IN THE DRAWINGS

Replacements sheet for Figs. 7, 13, 14, 15 and 16 are submitted herewith. The replacement sheets are submitted to correct minor errors that occurred during the preparation of the formal drawings after the application was filed. The amendments remove the minor errors and make the formal drawings consistent with the informal drawings that were originally filed with the application. The amendments to the drawings are fully supported by the drawings and specification as originally filed, and no new matter has been added.

Fig. 7

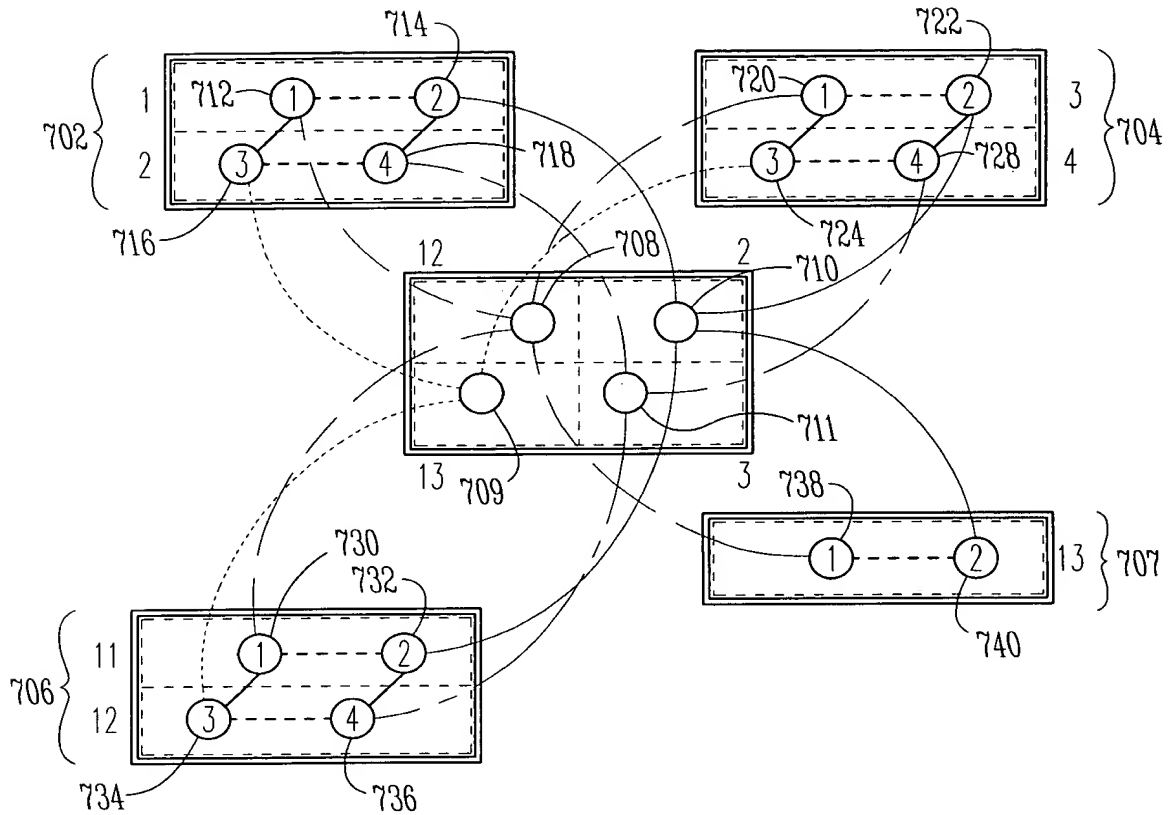
The formal drawing for Figure 7 contained an incorrect reference number. Reference number "604" is changed to "704" in the replacement sheet for Figure 7. The formal drawings for Figures 13, 14, 15, and 16 each incorrectly show the second router of the fourth cluster in the bottom row (the cluster shown with numbers 13, 14) and the second router in the sixth cluster in the bottom row (the cluster shown with numbers 15, 16) both connected to router number two in the middle metarouter of the middle row. The corrected formal drawings remove the connection from the fourth and sixth clusters to router number two in the middle metarouter of the middle row.
